**CHATFIELD DAM & LAKE
DENVER, COLORADO**

ANTECEDENT FLOOD STUDY FINAL REPORT

**TRI-LAKES REALLOCATION FEASIBILITY STUDY
DECEMBER 2005**

Independent Technical Review Comments and Responses

Figure 5 Antecedent Precipitation Ratios

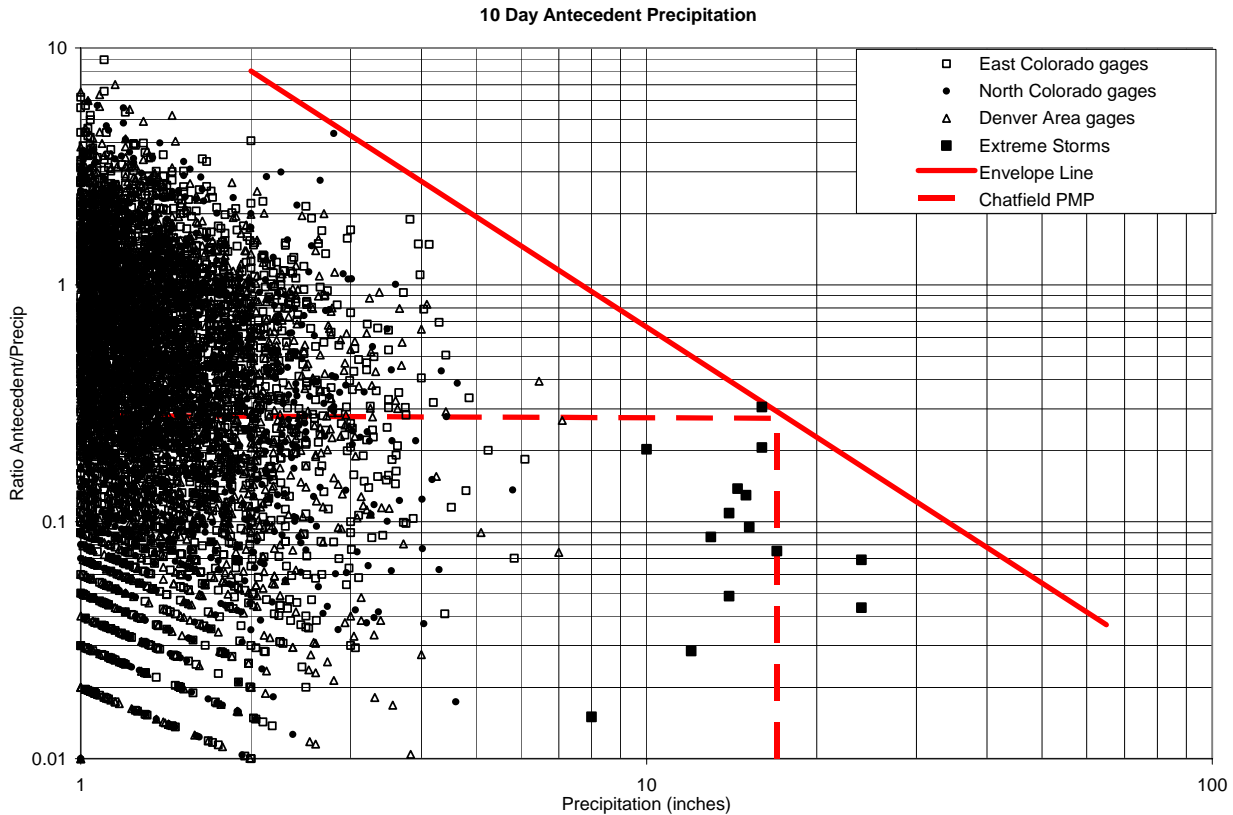
The approach initiated by the COE using historical precipitation data with tentative results shown in table 2 and displayed on figure 5 of the draft report basically follows the initial standard methodology used in all reports that are developed by the NWS in the determination of the magnitude of the antecedent precipitation in relation to the PMP. However, there are several questions that need to be addressed to ensure the completeness/accuracy of the final results. These are:

b. The relationship described on figure 5 is basically derived using point precipitation data. The drainage area above Chatfield Dam is 3018 square miles. Studies that involve drainage sizes larger than 100 square miles should evaluate the effect of large area storms. This is accomplished by studying clusters of precipitation stations, both antecedent and during the main precipitation event for storm area sizes similar to that of the drainage area size of interest. Major storms of record, as found in "Storm Rainfall of the United States," are useful to describe average precipitation depths for area sizes of interest in the main storm event. Typically, there is not an observed change in the ratio of the antecedent storm magnitude to the main storm for small area sizes (< 100 sq. mi.) but as storm area size increases the ratio usually increases somewhat.

e. In table 2 of the draft report, the June 17, 1965, Holly, Colorado precipitation is shown as 26 inches. We are not aware of a 24-hour precipitation amount of that magnitude occurring at that location on that date. McKee and Doesken (“Colorado Extreme Storm Precipitation Data Study”, May 1997) reported only 15.17 inches in 48-hours at Holly on that date.

f. In table 2 of the draft report, the ratio for the June 17, 1965, Falcon, Colorado storm is given as 0.306. This data does not appear to be plotted on figure 5. Doing so would raise the ratio value stated at the bottom of page 7 to near 30 percent and change the “Historic Envelope - Antecedent Precipitation” value shown in table 3 to near 30 percent.

RESPONSE: Concur that a cluster analysis would likely result in the main event values being smaller than those from a single station value since more than 1 station values

RESPONSE: Concur with comment. Holly precipitation revised in table 2 and on Figure 5.

RESPONSE: Concur with comment; value plotted on Figure 5 was based on antecedent precipitation at the Ayers Ranch gage. This was later changed to Colorado Springs which was slightly higher. This has been revised and the envelope curve has been modified.

Figure 7 Chatfield Reservoir Pool Probability

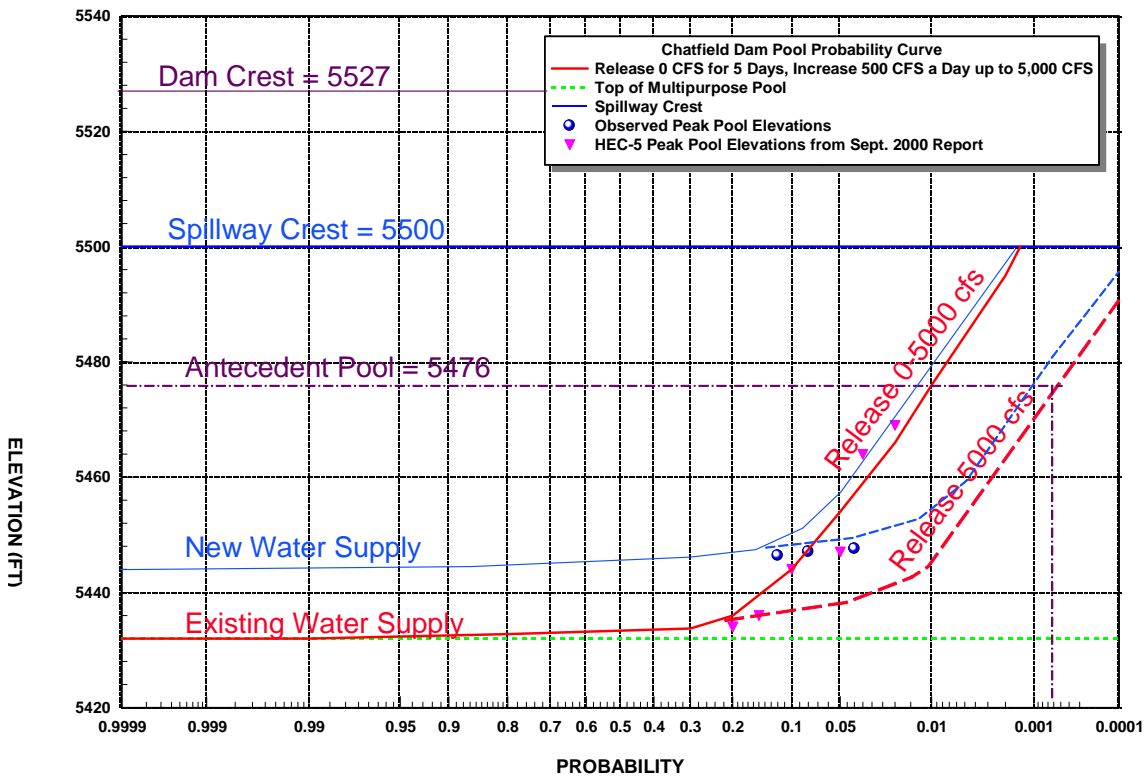
5. Page 13, first paragraph and Figure 7. The text indicates that the six highest pool elevations simulated with the HEC5 model of the Tri-Lakes system are shown on Figure 7. What operating rules were used to determine the highest pool elevations? It is not stated in the text, but I assume that the pool elevations were determined by using zero releases for five days, followed by increases of 500 cfs a day up to a maximum of 5000 cfs.

RESPONSE: The HEC5 model study utilized operating criteria from the Water Control Manual which included a target flow at Denver of 5,000 cfs and a maximum increase in release of 500 cfs per day. It also included balancing storage at Bear Creek and Cherry Creek reservoirs. Therefore, the operating criteria in the HEC5 model would generally follow the zero to 5,000 cfs release schedule used for developing the pool probability relationships. These values were used for comparison to validate the pool probability relationship based on simulation of historical flows.

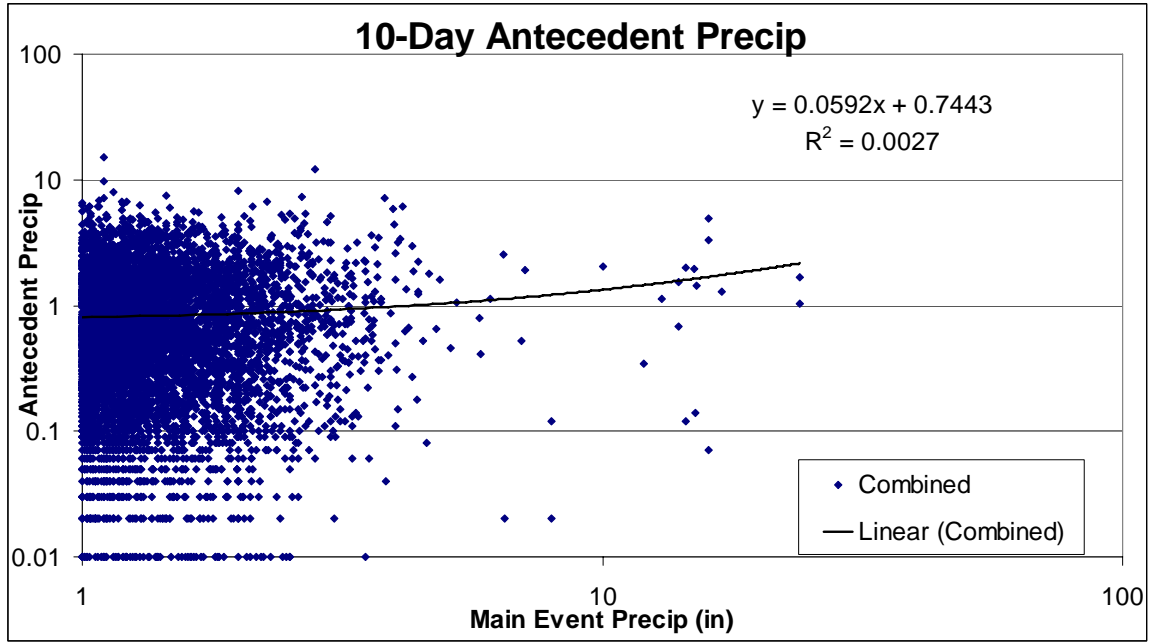
Technical Paper No. 49 (TP49) “Two- to 10- Day Precipitation for Return Periods of 2 to 100 Years in the Contiguous United States” provides the opportunity to quickly examine precipitation ratios formed between durations of intense precipitation (main event) and remaining precipitation (antecedent) derived from a precipitation frequency analysis. In this case, one can quickly find the average 4-day, 100-year precipitation and a similar value for a 10-day, 100-year amount for the Chatfield drainage. For example, in the Chatfield drainage (eye-ball estimate) the 4-day, 100-year precipitation equals 4.9 inches, whereas the 10-day, 100-year precipitation equals 5.9 inches. The difference between these values is 1.0 inch, resulting in a ratio of 0.20 (1.0/4.9). Using a 2-day, 100-year value (4.5 inches) with the 10-day, 100-year value

(5.9 inches) yields a ratio of 0.31 (1.4/4.5). Various other ratios can be formed through interpolation/extrapolation to test extremes using this information. Justifications/reasoning would have to be employed to evaluate results. Ideally, one would like to have such precipitation frequency analysis carried out to additional days and longer return periods similar to what is available for the Southwestern States and the Ohio River Region (NOAA Atlas 14). One needs to evaluate the limitations of forming ratios in this manner. Is the evaluation of 100-year precipitation applicable to events at the level of PMP? It is unlikely that the many main events (2- or 4-days) are part of the 10-day event. Also these ratios are from point precipitation (station) analysis and do not include storm area analysis [guidance on adjustments for spatial considerations could be applied from results from methodologies (1) and (3) noted in this review]. The reasonableness of the selected durations of main and antecedent storm lengths needs to be evaluated. The purpose of the draft study is not necessarily to derive an absolute value of the antecedent storm event but to provide enough evidence that the relationship between the antecedent precipitation event and the PMP would form a ratio of < 40 percent. If reasonable combinations cannot exceed a ratio greater than 40 percent, then the COE goal criteria have been satisfied.

RESPONSE: As suggested in this comment, an additional analysis was performed using 24-hour precipitation frequency obtained from NOAA Atlas 2 – Volume III Colorado and 10-day precipitation from Technical Paper No. 49. The largest point precipitation values in the vicinity of Chatfield Dam were used in this analysis. Precipitation values for 500-year frequency events were extrapolated using a normal-probability distribution. Ratios were computed by subtracting the 24-hour precipitation from the 10-Day precipitation and then dividing by the 24-hour precipitation. This represents a statistically based analysis with the 24-hour value as the main event and the difference between the 10-Day and 24-hour value as the antecedent precipitation. Results of this analysis indicated that the Ratio is always less than 40 percent throughout the entire range of frequencies as shown in the following table:
